# AMPEX

SERVICE BULLETIN

DATE: 20 March 1953  
MODEL: 300  
BULLETIN NO: 2  
PAGE NO: 1

### REPLACEMENT INSTRUCTIONS FOR REPLACING CYCLOHM DRIVE MOTOR OR ELECTRIC INDICATOR MOTOR WITH BODINE DRIVE MOTOR, SERIAL NOS. 113 TO 699

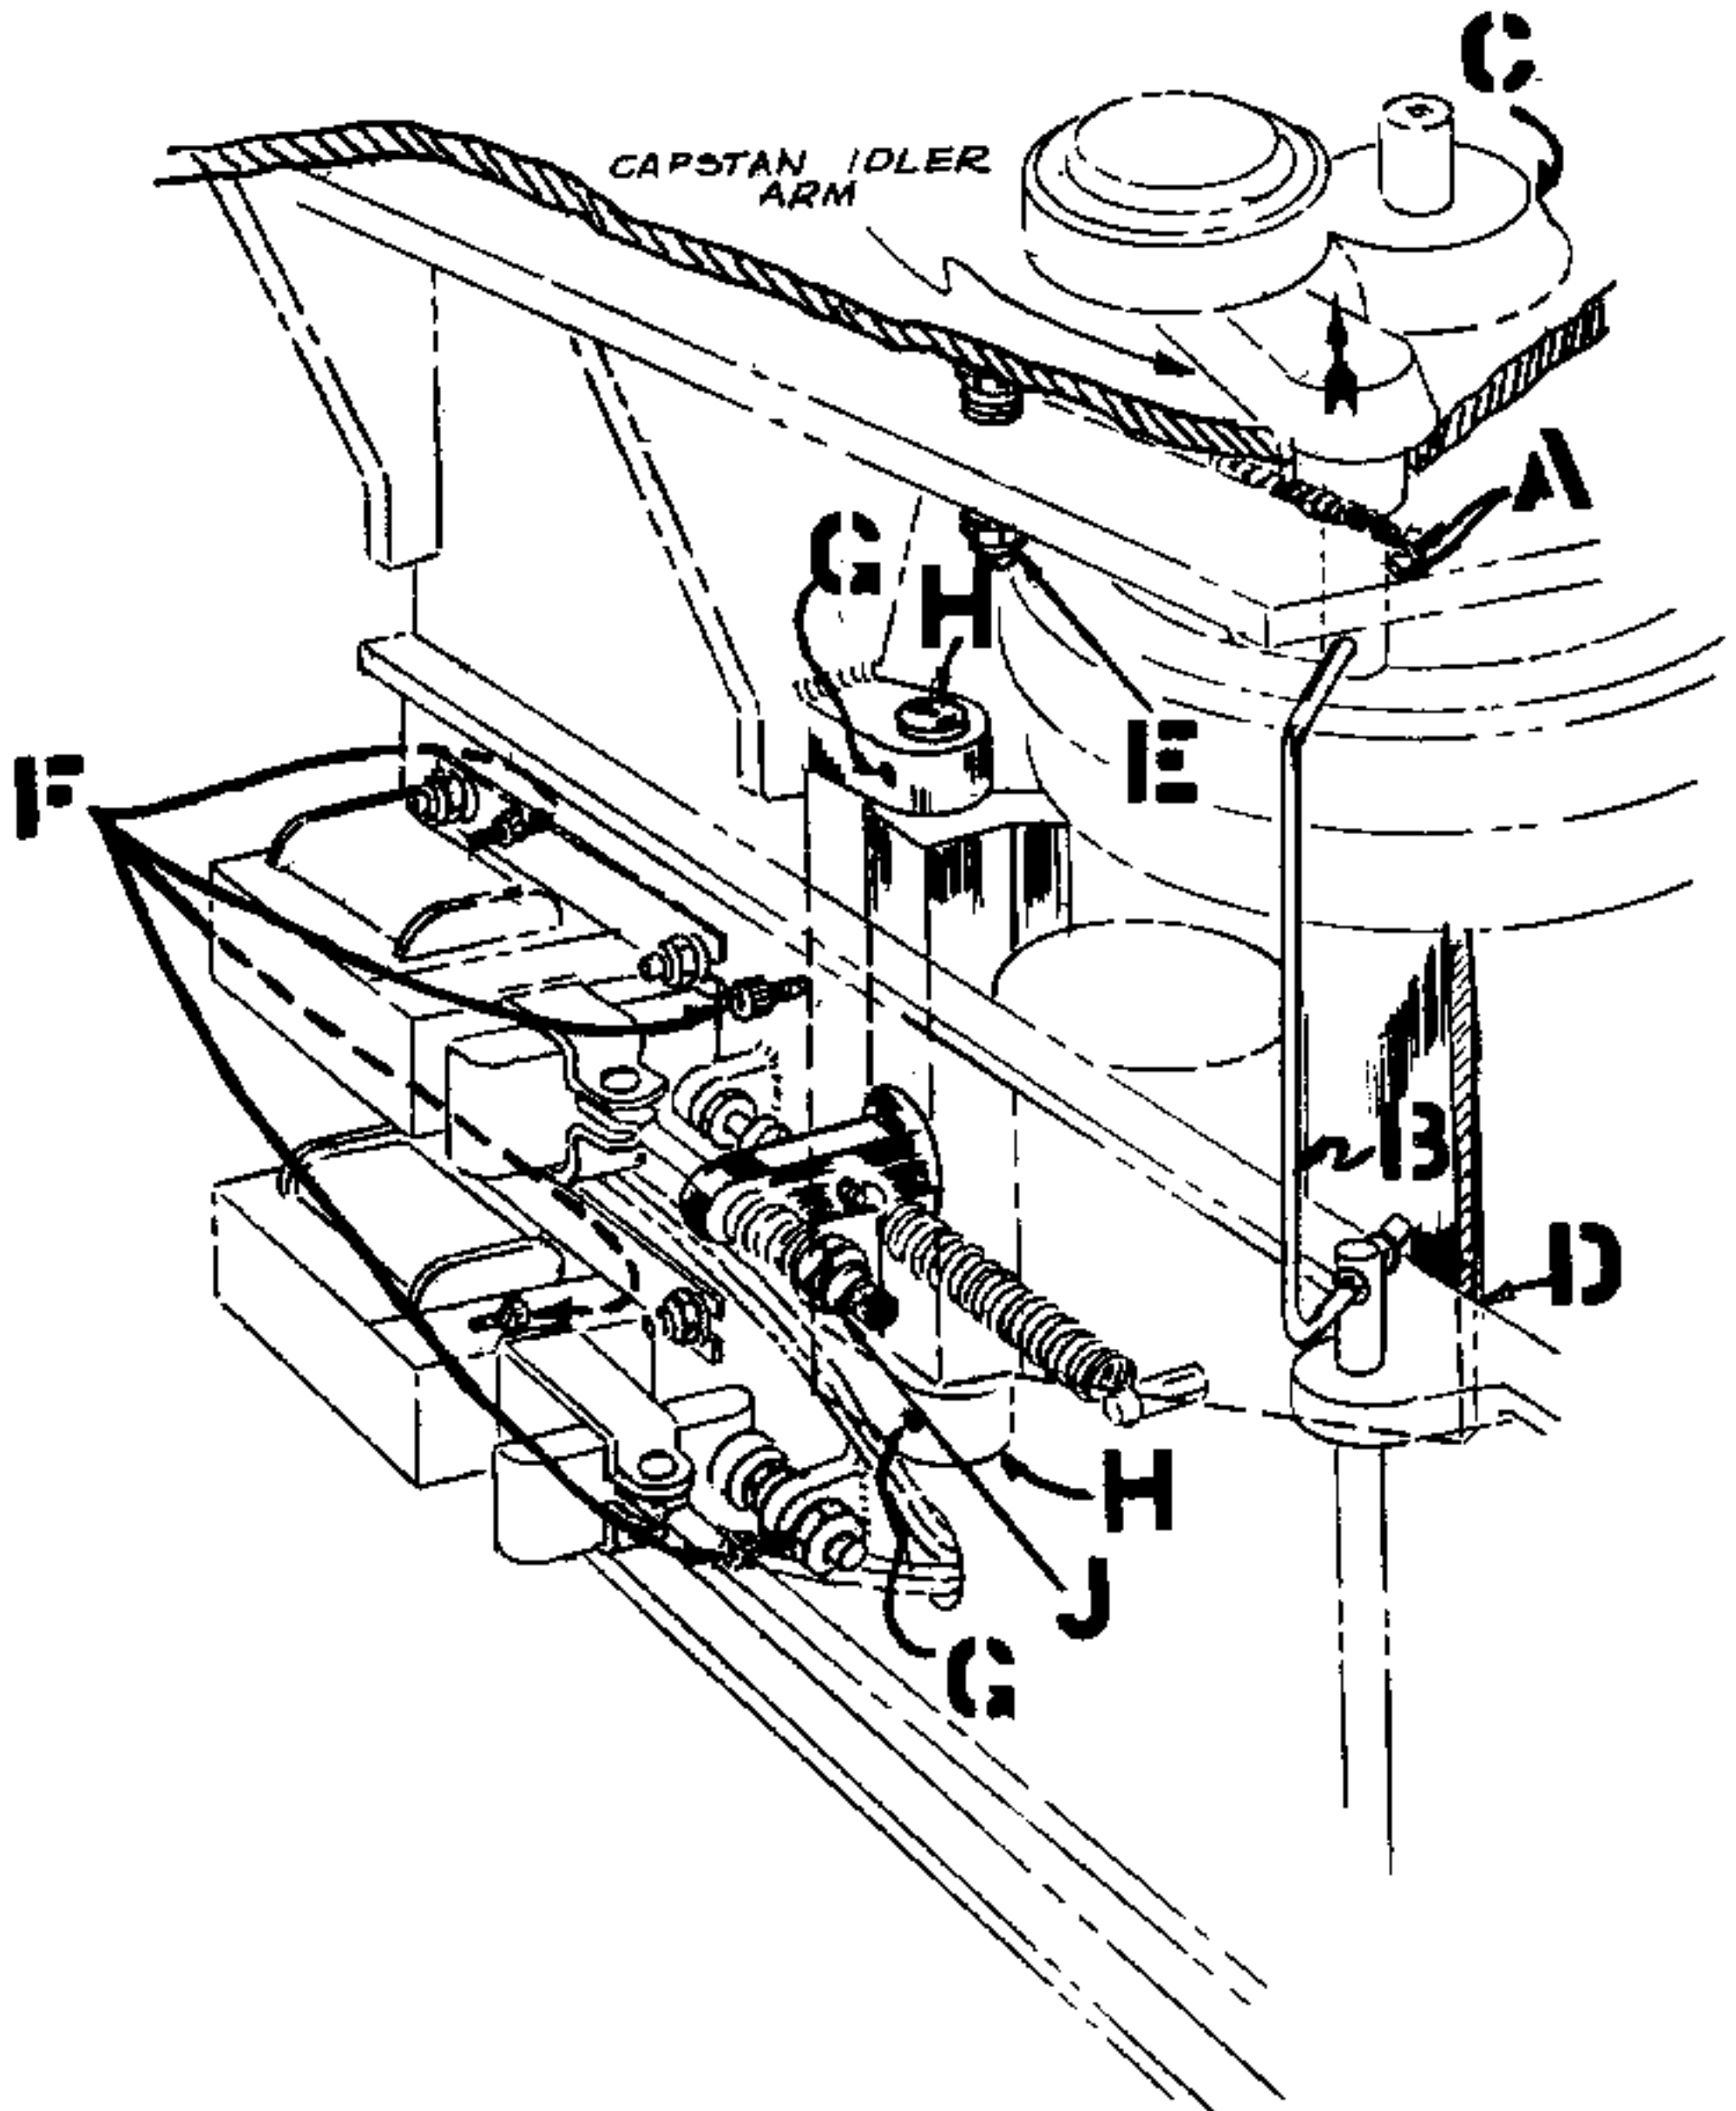
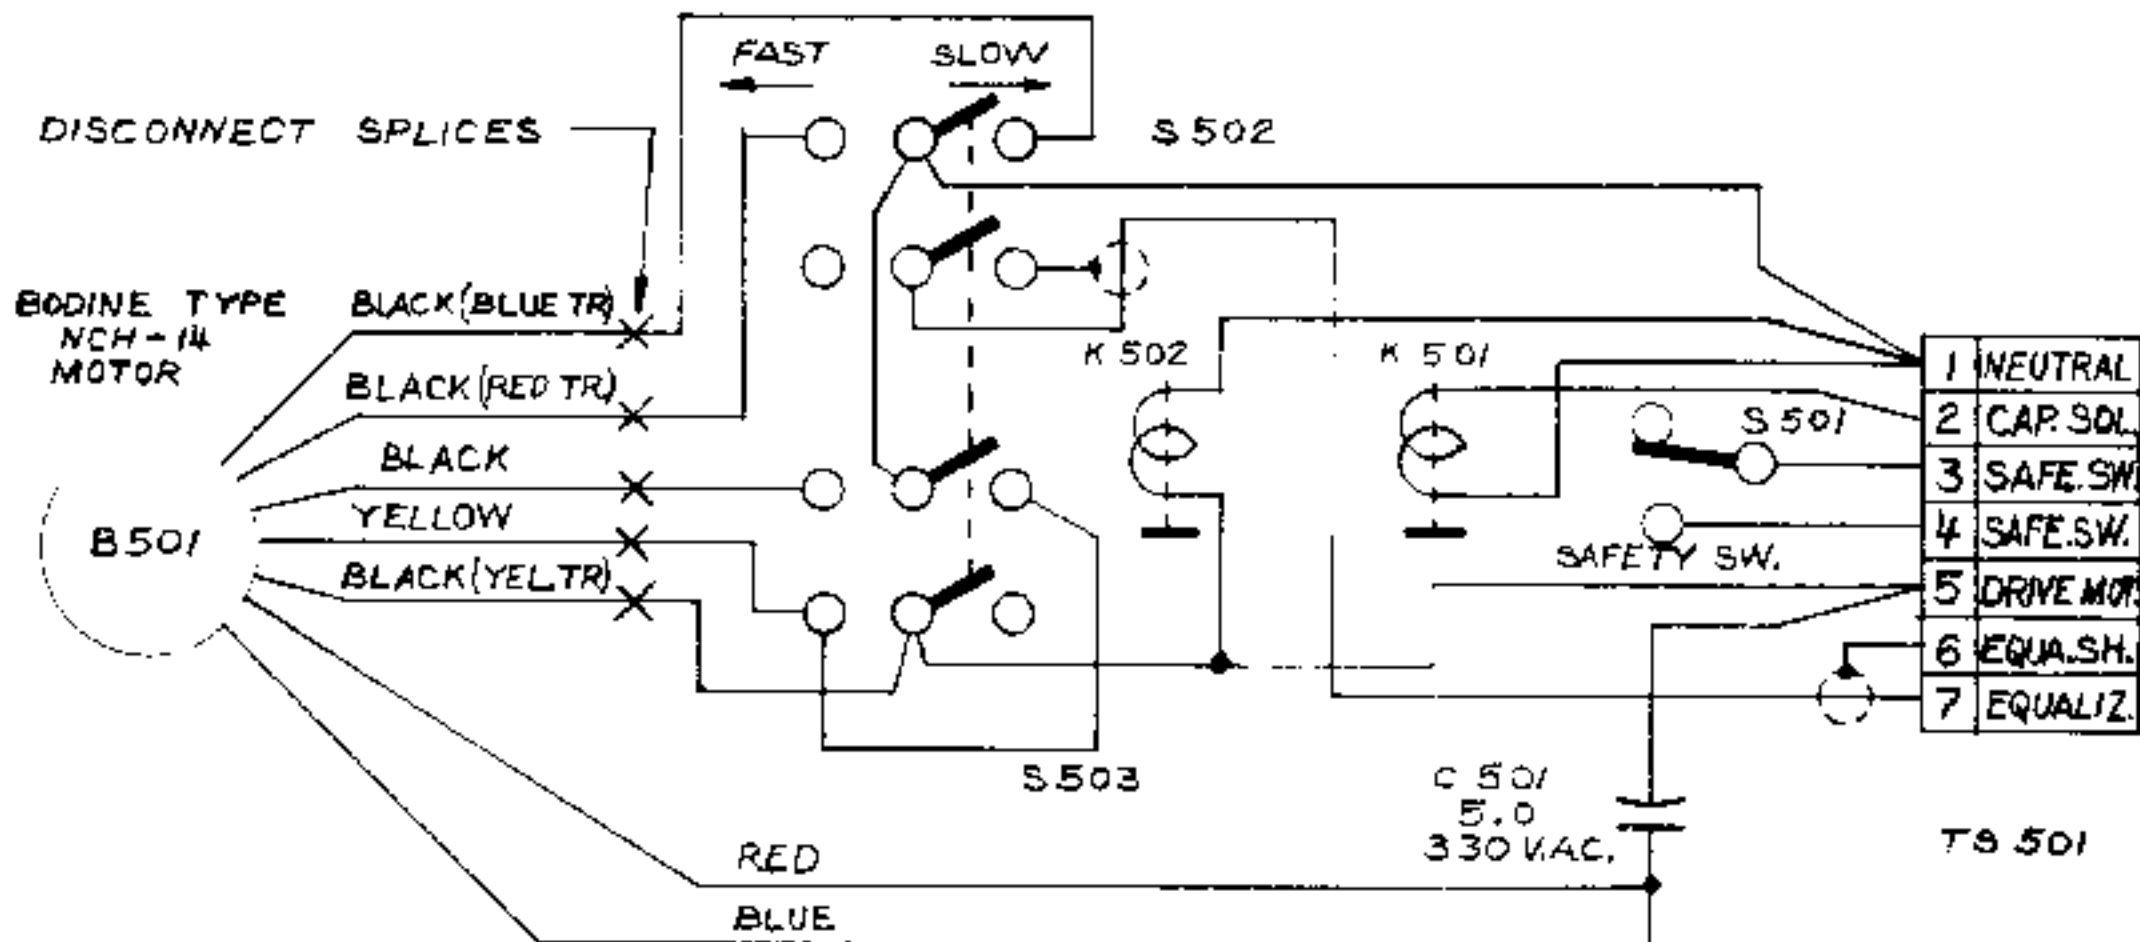
The Bodine Drive Motor which has been developed for the Model 300 runs at double the speed of the Cyclohm or Electric Indicator Drive Motor used on machines of Serial #113 to 699 and consequently uses a different size pulley. To install the Bodine Drive Motor therefore requires that a new hinge bracket be installed which will support the new motor in the proper position to engage the capstan flywheel. Also, since the windings on the Bodine Motor are different than on either the Cyclohm or Electric Indicator Motors, it must be connected in a different manner.

1. Remove retaining rings "A" on Capstan Idler link "B".
2. Remove Capstan Idler link "B".
3. Remove Capstan Idler arm from Top Plate.
4. Remove Capstan cap by loosening set screw "C".

5. Disconnect wiring harness from Drive Assembly terminal strip "D".
6. Remove Drive Assembly from machine by removing 4 elastic stop nuts "E" (only one shown).

7. Remove 4 screws "F" and drop solenoid mounting plate. Note that two screws are on the solenoid side and remainder on the opposite side of the plate.

8. Carefully remove drive lok pins "G". Be careful not to damage ears of casting.
9. Remove two bracket hinge pins "H".
10. Remove bearings from old brackets and install in new bracket.

14. The bumper should not determine the rest position of the motor. The bumper merely serves as an override bumper to damp out any motor oscillation that would cause it to bounce against tire after solenoid is de-energized. The rest position is determined by the motor spring versus the pressure of the drive solenoid spring adjustment. When properly adjusted the bumper should not quite touch motor while at rest except during shipment.
15. For modified wiring for Bodine Motor see attached wiring Diagram EA-1752.

ALLOW 8" LEAD LENGTH  
FROM MOTOR TO DIS-  
CONNECT SPLICES
